Access Compliance Report

Public Rights-of-Way

Intersection ID: 12413	Main Street: N_BREVARD_ST	Cross Street: E_6TH_ST	Location: E
ADA ID: 563C7AA8A0D5	Ramp Type: PerpDiag	Initial Pass/Fail: Pass	Overall Compliance: No
Severity Score: 0.25			
Codes/Mitigation Info/Possible Solution		Field Measurements/Component Compliance

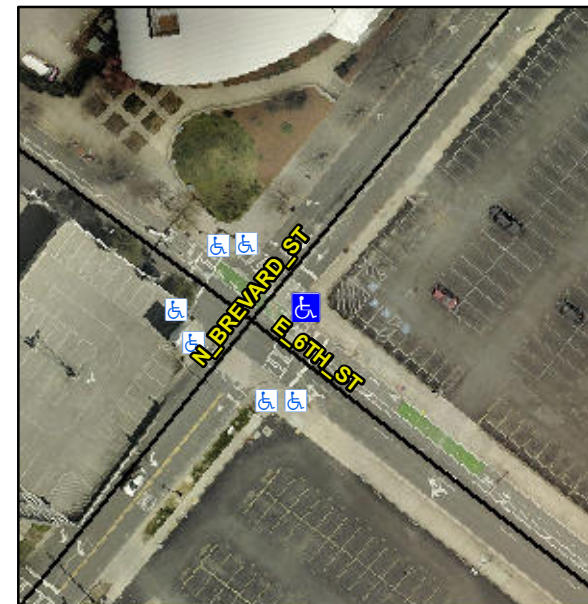
R304.2.1, R304.2.2-Perp, R304.3.2-Para, R304.5.3, R305.2

Compliance	Description	Data	Compliance	Description	Data
N/A	Ramp Length (in)	64.0	Yes	Ramp Slope (%)	7.5
Yes	Ramp Width (in)	48.0	Yes	Ramp XSlope (%)	3.3
N/A	Flare Type LT	Sloped	N/A	Flare Type RT	N/A
N/A	Flare Slope LT (%)	8.3	Yes	Flare Slope RT (%)	7.1
N/A	Flare Traversable LT?	Yes	N/A	Flare Traversable RT?	Yes
No	Landing Length (in)	48.0	Yes	DWS Provided?	Yes
Yes	Landing Width (in)	48.0	Yes	DWS Contrast?	Yes
No	Landing Slope (%)	3.7	Yes	DWS Length (in)	24.0
No	Landing X Slope (%)	3.8	Yes	DWS Full Width?	Yes
N/A	Landing Curb? (Y/N)	Yes	No	DWS Offset (in)	15.0
N/A	Shared Landing?	No			
Yes	Gutter Ponding?	No	Yes	Gutter Slope (%)	2.8
Yes	Gutter Lip Ht (in)	0.0	Yes	Gutter X Slope (%)	1.7
N/A	Painted X Walk1?	Yes	N/A	Painted X Walk2?	Yes
	X Walk 1 Direction	To NW		X Walk 2 Direction	To SW
N/A	X Walk 1 Width (in)	104.0	N/A	X Walk 2 Width (in)	108.0
	X Walk 1 Slope (%)	2.9		X Walk 2 Slope (%)	0.6
	X Walk 1 X Slope (%)	1.3		X Walk 2 X Slope (%)	1.6

Remove & Replace Curb Ramp With Two New Directional Ramps or Equivalent.
